2. Planning and Land Use Committee – July 17, 2014

5. Rezoning Application # 00427 and Development Permit Application # 000340 for 1515 Douglas Street and 750 Pandora Avenue:

Re: Review by HAP and ADP of the Revised Application to the City of Victoria for a New Comprehensive Development Zone, Development Permit, and OCP Amendment pertaining to Lands Municipally Described as 1501 Douglas Street, 1509-1517 Douglas Street, and 750 Pandora Avenue, Victoria, BC

Rendered View of the 1515 Douglas Plaza at Pandora Avenue

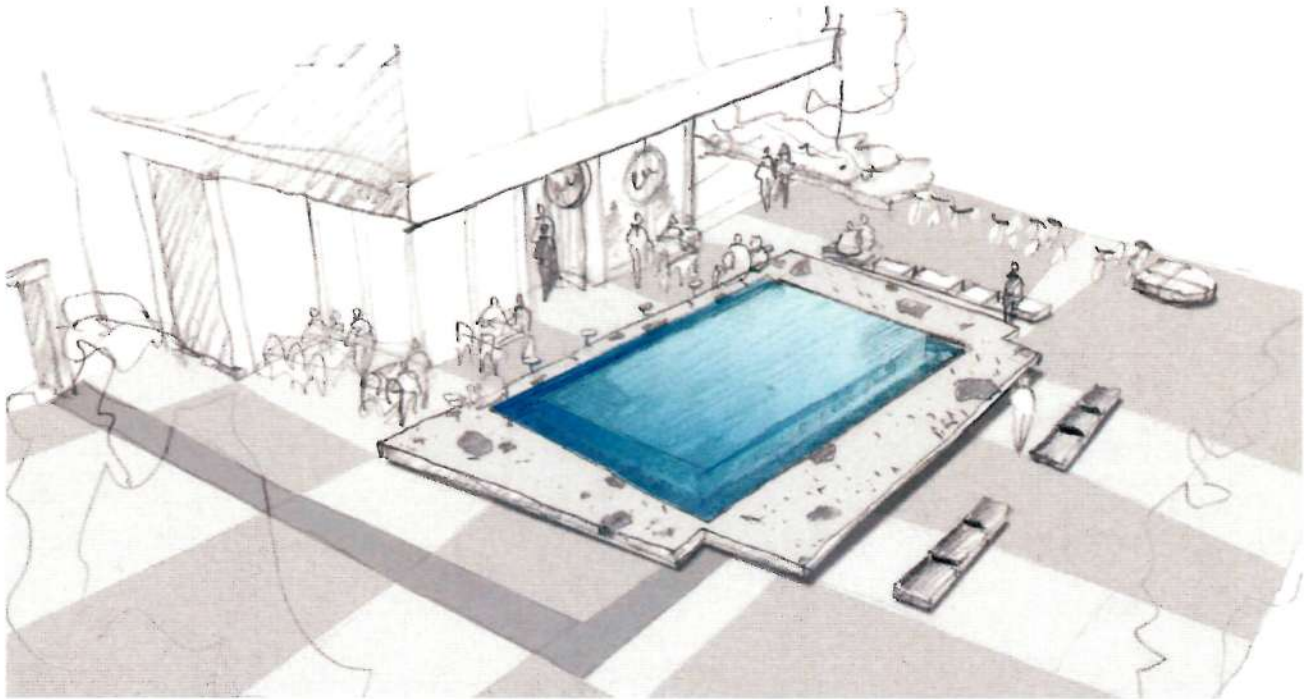
1. whether the design of the proposed Phase One building and public plaza sufficiently responds to the inflection in the street grid at Douglas Street and Pandora Avenue;

2. whether the proposed building massing and design of the plaza facing Douglas Street adequately respond to City Hall as a Heritage Landmark Building and the Landmark Building policy in the *Downtown Core Area Plan*;

Landscaping and trees have been limited in the Douglas Plaza in response to the mandate from Planning staff that the design should maintain clear sight lines to City Hall and allow flexible use of the public spaces. The hardscaped surface has been graded so that it integrates seamlessly with the surrounding sidewalks and encourages pedestrian circulation through the plaza spaces. As the plaza is located over the underground parking structure, plaza plantings require raised planters; these have been located so that they do not interrupt the circulation flow into the Plaza but rather define its public edges. There is ample landscaping surrounding the site. Generously landscaped rain gardens along the site perimeter provide shade and soft texture along the bounding sidewalks and the Pandora bike laneway. In contrast to the 1515 Douglas Plaza, the entrance court at 750 Pandora is richly green-landscaped; the urban and landscape design of each plaza has been carefully calibrated to suit their intended character, location and use.

At the corner of Douglas Street and Pandora Avenue, the open space is continuous with the central Plaza area but is furnished to provide opportunities for seating and pause. A row of stone benches forms a permeable boundary at the property corner, subtly defining the transition between public sidewalk and the plaza while providing comfortable seating. These benches frame the main element of the plaza: a dramatic platform water feature that is both sculptural form and seating element. The water feature and its framing benches were designed so that the corner plaza accommodates both inward and outward viewing; visitors can choose to gather around the fountain or enjoy views of City Hall and the activity of this busy intersection.

While the detailed design of the platform and water feature is under development, we're able to share the ideas that have shaped this important urban amenity to date. The platform will be a large cementitious structure with a refined surface; the material will integrate stone aggregate and will be honed to a smooth finish. The water feature is set within this platform so that unintended contact with the water is largely prevented. The pool itself will be tiered with an upper reflecting pool that spills over into a perimeter trough. The reflecting pool will be formed by a platform of cast glass units raised up as a positive form; the shape and materiality of the upper platform will be used to incorporate coloured light into the fountain at night and, if required, when the fountain is seasonally dry.

Perspective View from Blanshard and Cormorant Streets

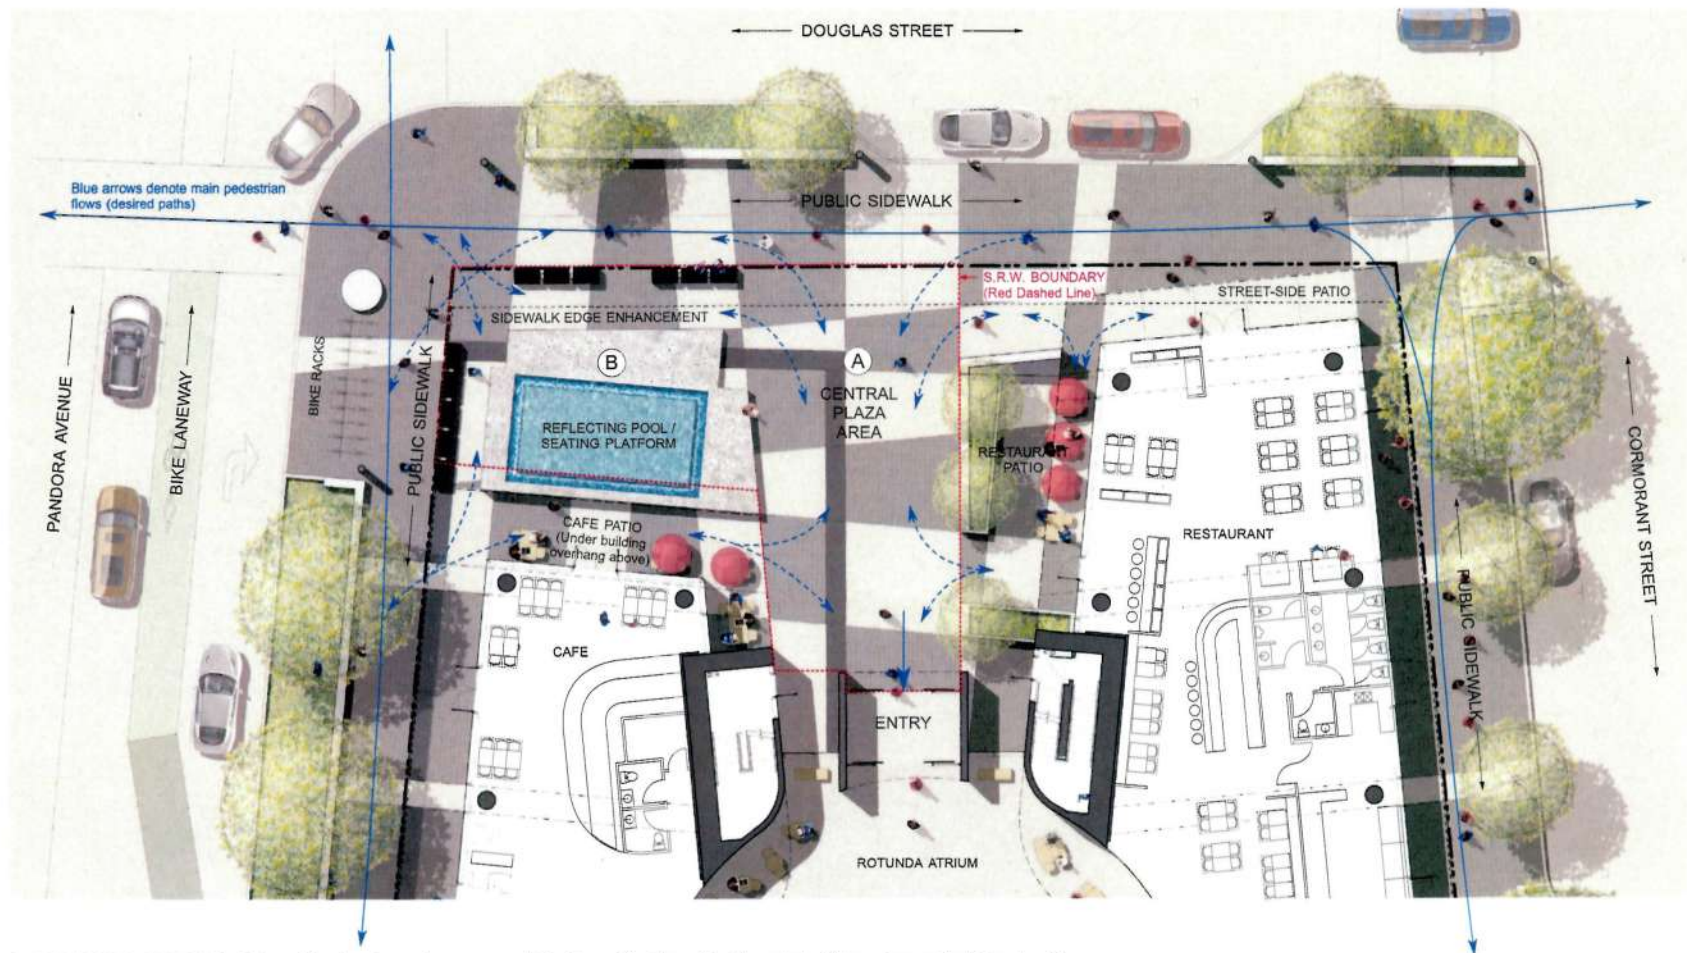
3. ADP Motion: *"More detail on the spandrel glazing system on the upper portion of the Phase Two tower."*

The 13-storey massing of the 750 Pandora building has been designed so that the building is visually divided into a 6-storey base and an upper 6-storey top, separated by a smaller 'reveal' floor. At this level, the space between upper and lower massings is used for unique mid-level terraces and green roofs. The smaller 7th floor provides a significant visual break between the upper and lower forms and emphasizes the continuity of structural columns between the building base and top. The line of glazing on this special floor is set back approximately 18" from the face of the column cladding, creating a shadow line between columns on the east and west facades consistent with the suggestions of the ADP. To further emphasize this level as a reveal between massing forms, the glazing is extended to a lower than typical sill and mullions are all SSG (no visible mullion 'caps' are used at this level).

In response to the ADP comments, we have revisited the material cladding at the Level 7 columns. Although the building structure was continuous in the previous proposal, the variations in column cladding interrupted the visual continuity of the structural columns. In the revised design (illustrated below), the Level 7 columns are clad in the same material as at the upper form (spandrel panels comprised of metal panels behind glass) so that they are more clearly integrated with the building top and the vertical structure reads more clearly across this 'reveal' floor. The Level 7 soffit materials have also been adjusted to metal panels to improve the visual continuity between the soffit and the curtain wall facades above, while enhancing the drama of the horizontal shift.
